Proposal for amendment 1 (Phase 2) to Global Technical Regulation N° 7 (Head Restraints)

The text reproduced below was prepared by the expert from CLEPA aimed to amend the proposal of amendment 1 to Global Technical Regulation N° 7 Head Restraints proposed by Japan and the Informal Working Group on Phase 2 of Head Restraints in their document ECE/TRANS/WP.29/GRSP/2019/5 and updated by the IWG of phase 2 by GRSP-65-24. This document updates and replaces the document ECE/TRANS/WP.29/GRSP/2019/10 from Clepa by suppressing elements already taken into account by GRSP-65-24 and renumbering the remaining paragraphs accordingly. The modifications to the text of the UN Regulation are marked in bold for new or strikethrough for deleted characters.

"Figure 3-3
Portion of gap above 540mm.

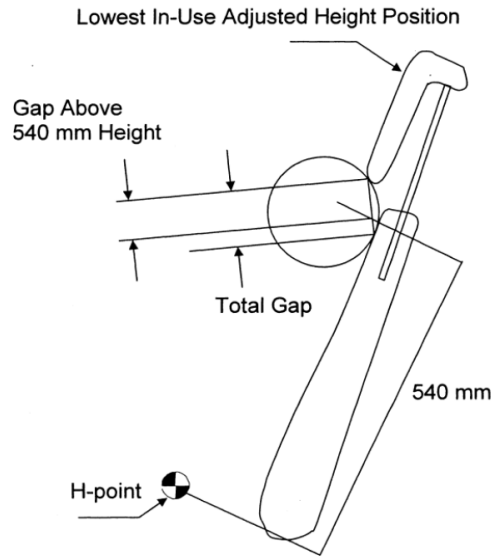
"2.3. The area of measurement is anywhere between two vertical longitudinal planes passing at 85 mm on either side of the torso line and above ~~the top of the seat back~~ **a height of 540 mm."**

"2.5. Determine the gap dimension by measuring the straight line distance between the inner edges of the two furthest contact points, as shown in Figures 3-1, ~~and 3-2 and 3-3.~~"

Annex 3, insert a new Figure 3-3, to read:

This document clarifies the way to apply and to understand GTR7 phase 2 static alternative provisions which have been detected being not fully clear. It also aligns the area where the gap is measured to actual practice in UNECE 17 and FMVSS 202a which consider only gaps over a height of 540mm.
